ADDENDUM TO RFP DOCUMENTS

<p>SOLANO COMMUNITY COLLEGE</p>	ADDENDUM #01
	Project: Solano Community College District Building Lighting Upgrade Project (Project #19-001)
	Date: January 4, 2019

ITEM NO. 1 – REVISIONS TO ELECTRICAL PLAN SHEETS

E0.30

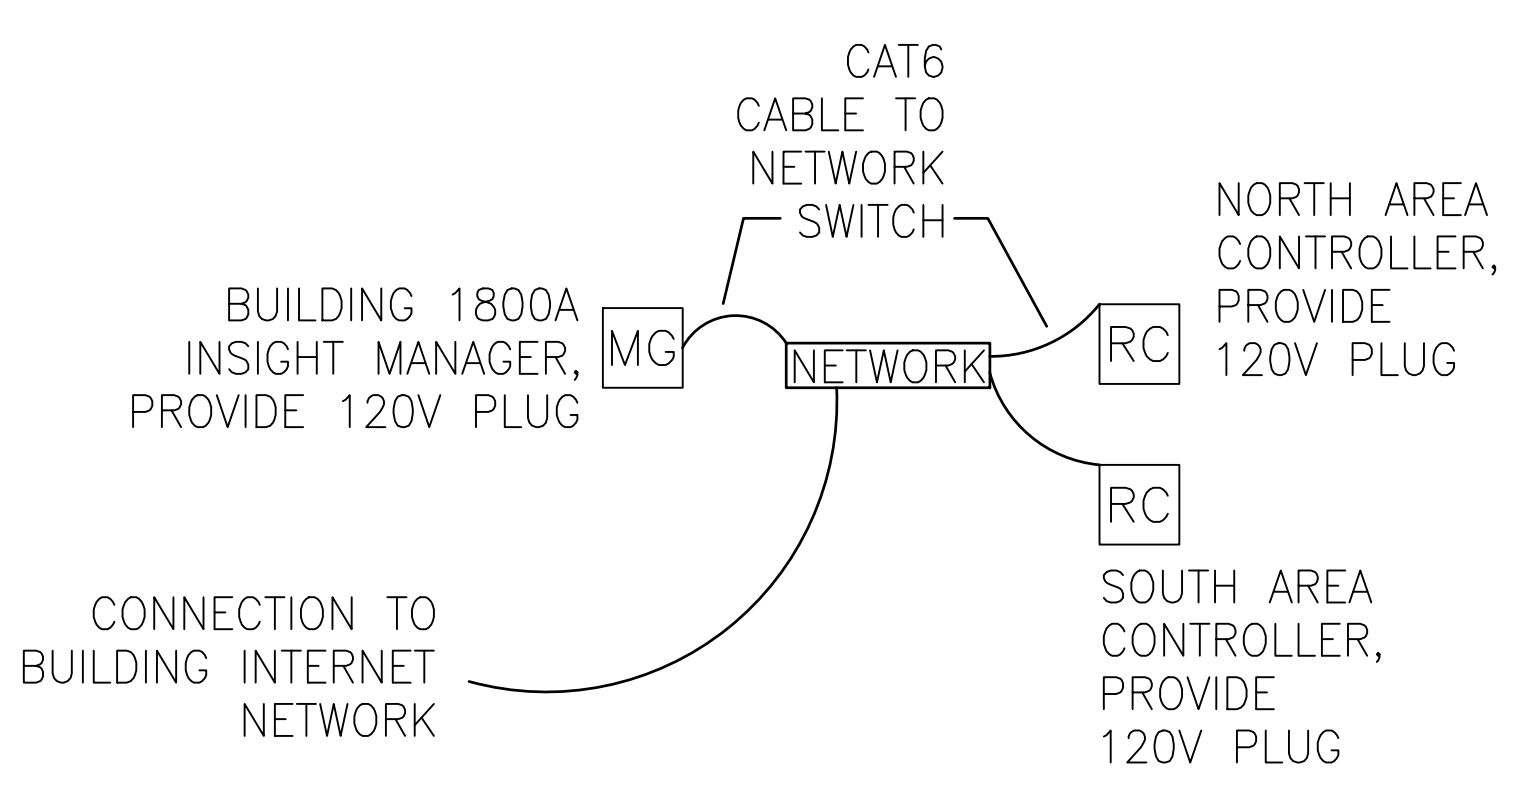
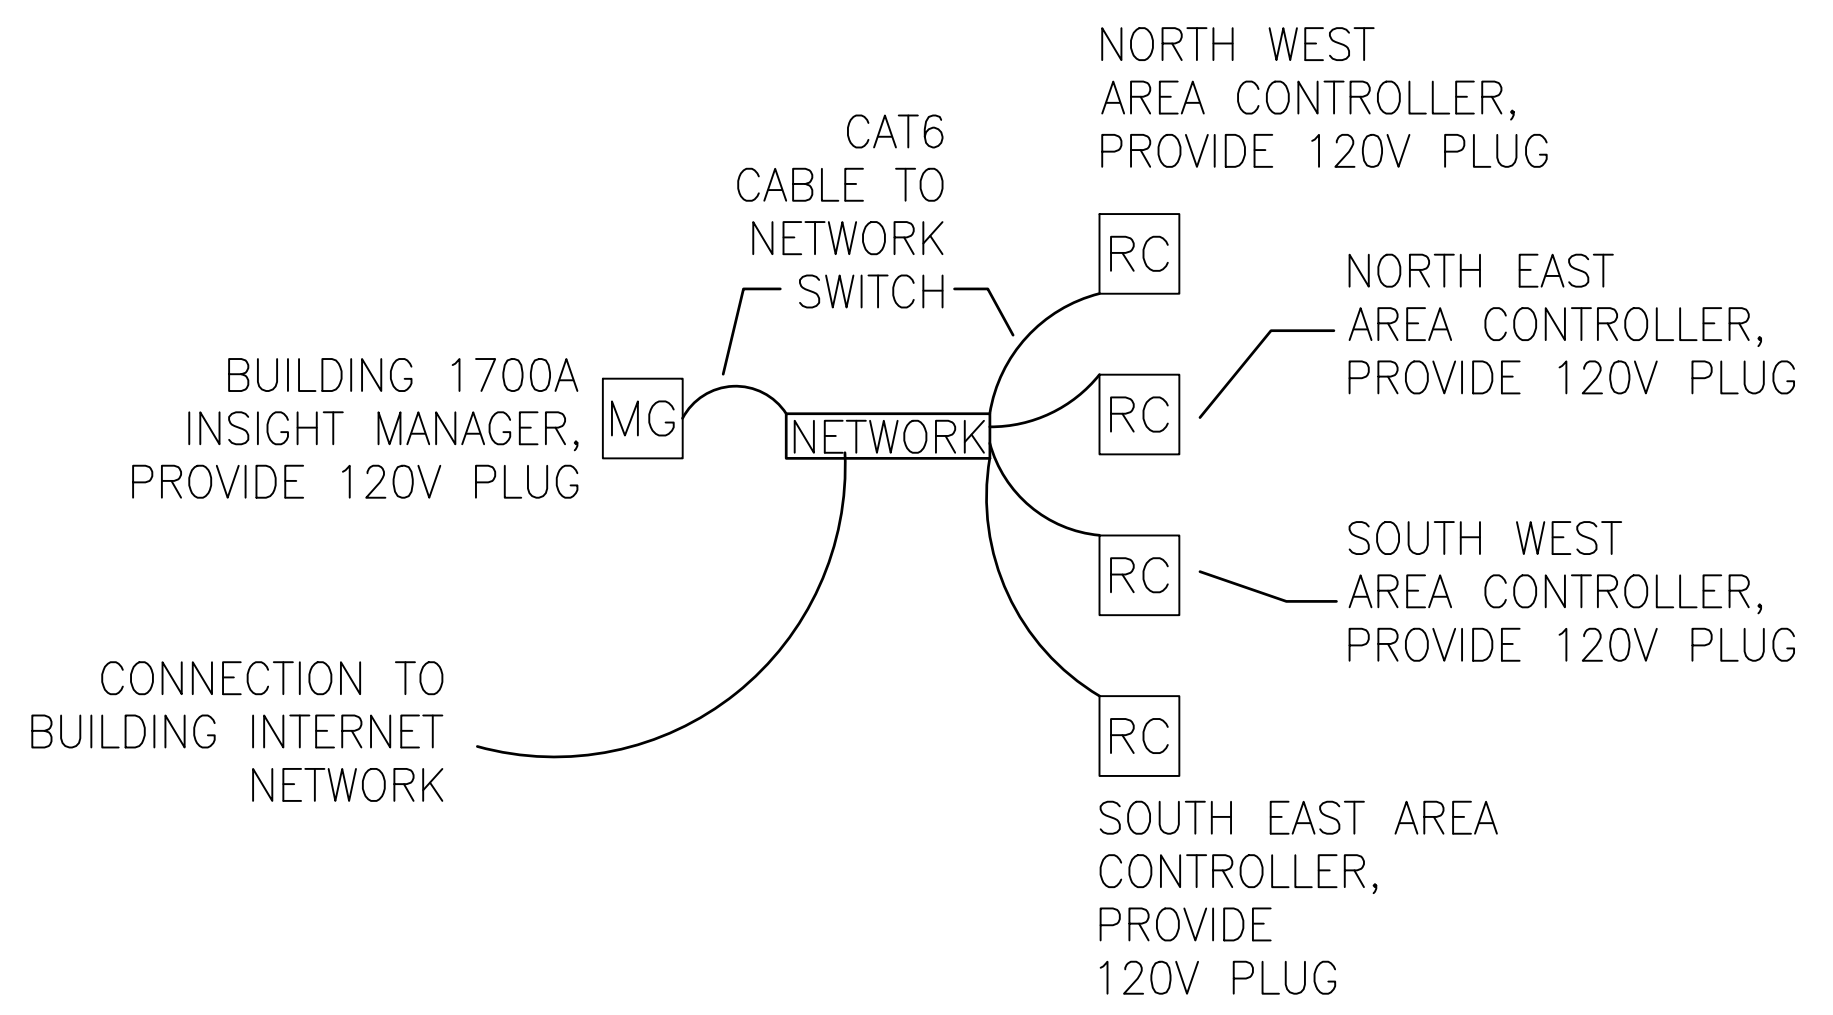
Sheet E0.30 – Revised fixture type E1 to include surface mounting kit for Building 1800A.

E1.00

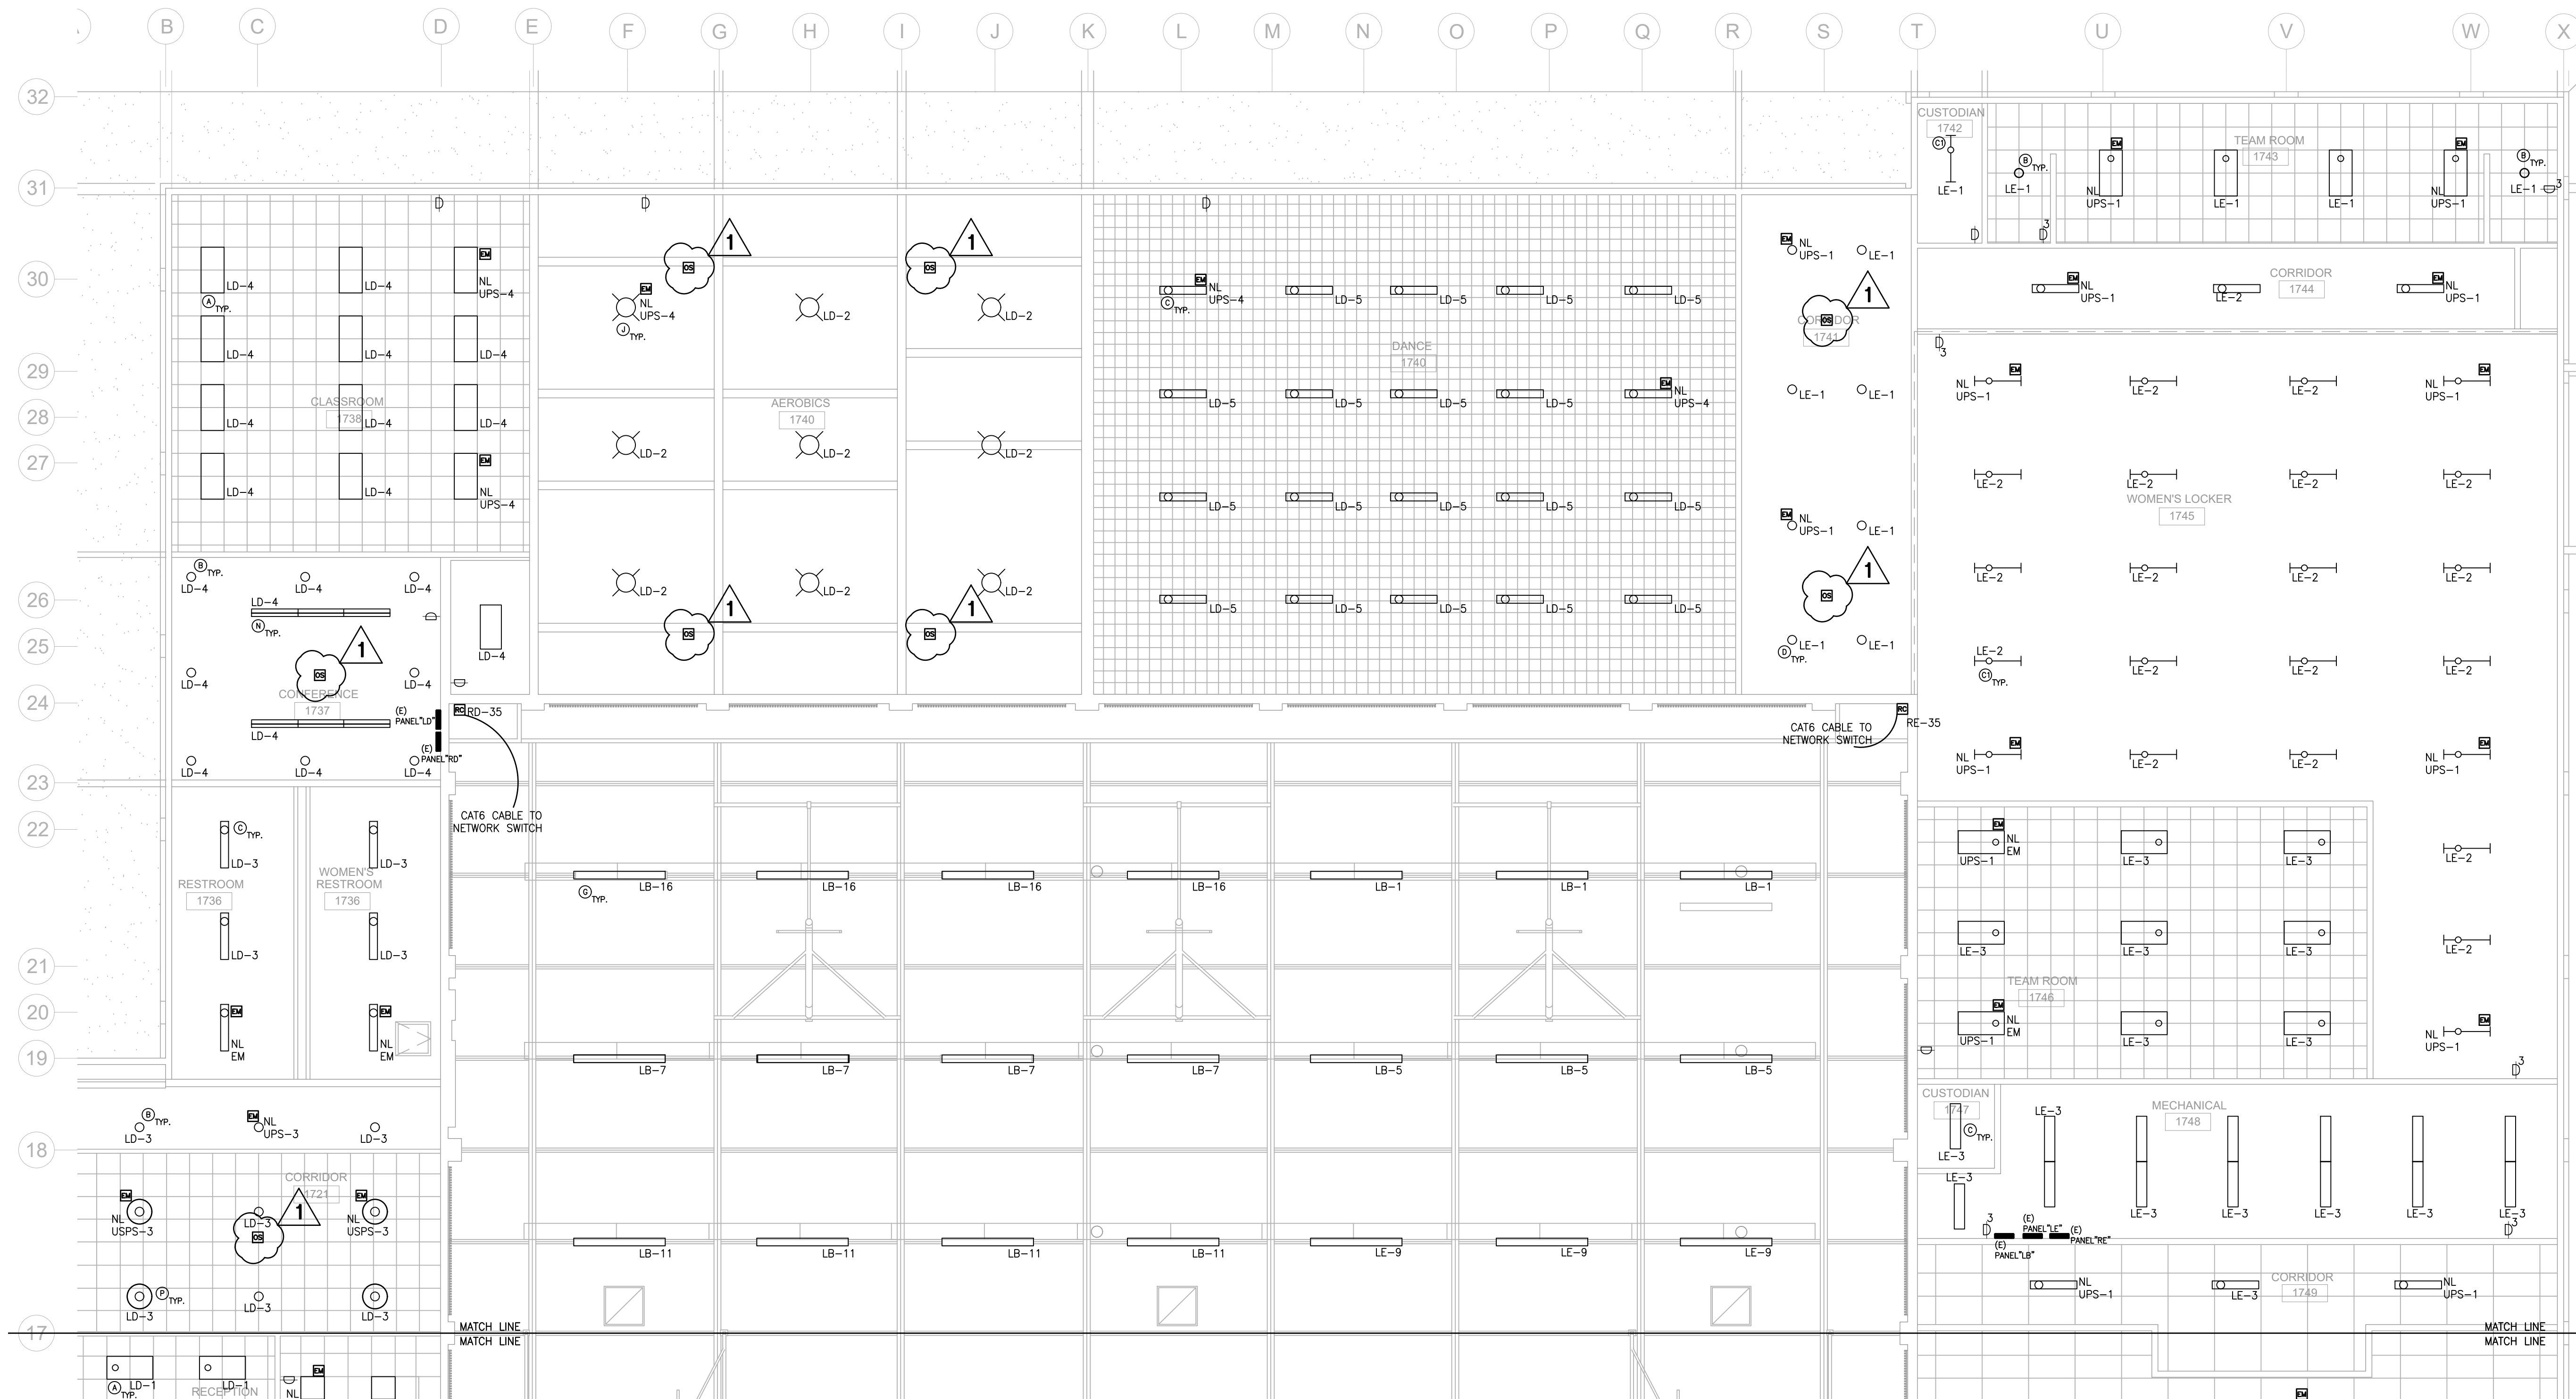
Sheet E1.00 – Added symbols to clarify the need for occupancy sensors for fixture types that are not equipped with integrated sensors.

E1.01

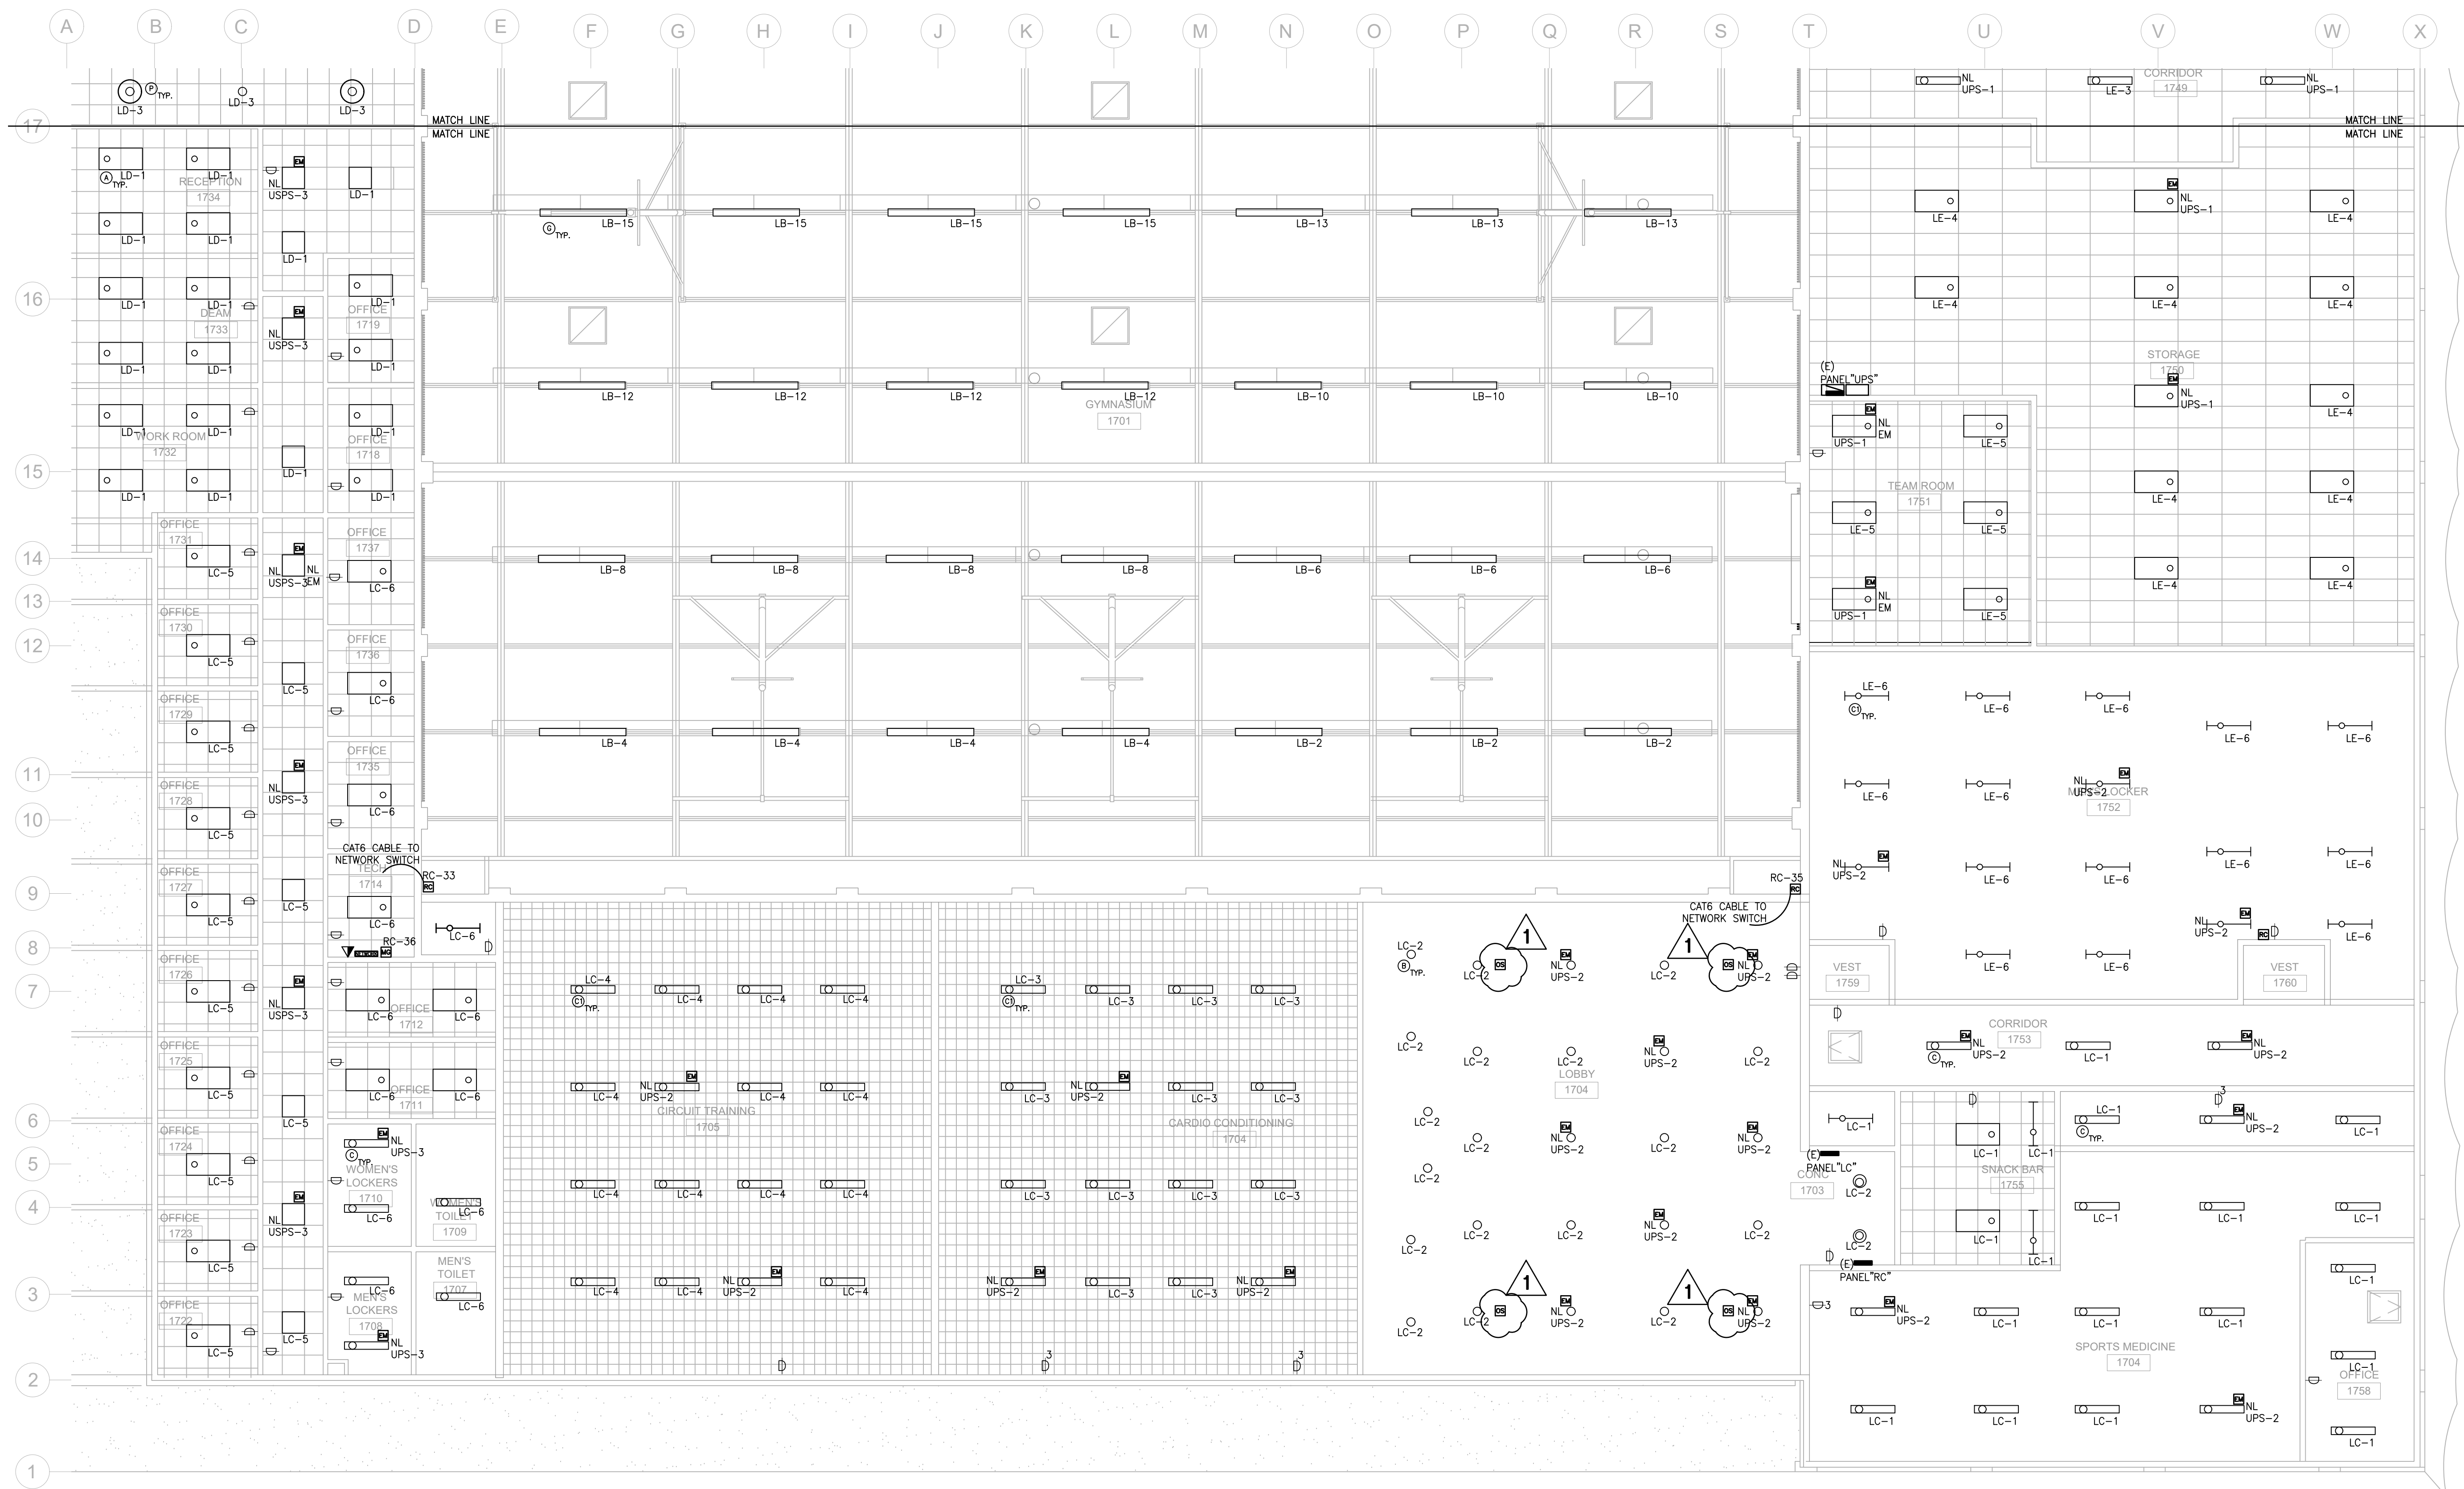
Sheet E1.01 – Added symbols to clarify the need for occupancy sensors for fixture types that are not equipped with integrated sensors.
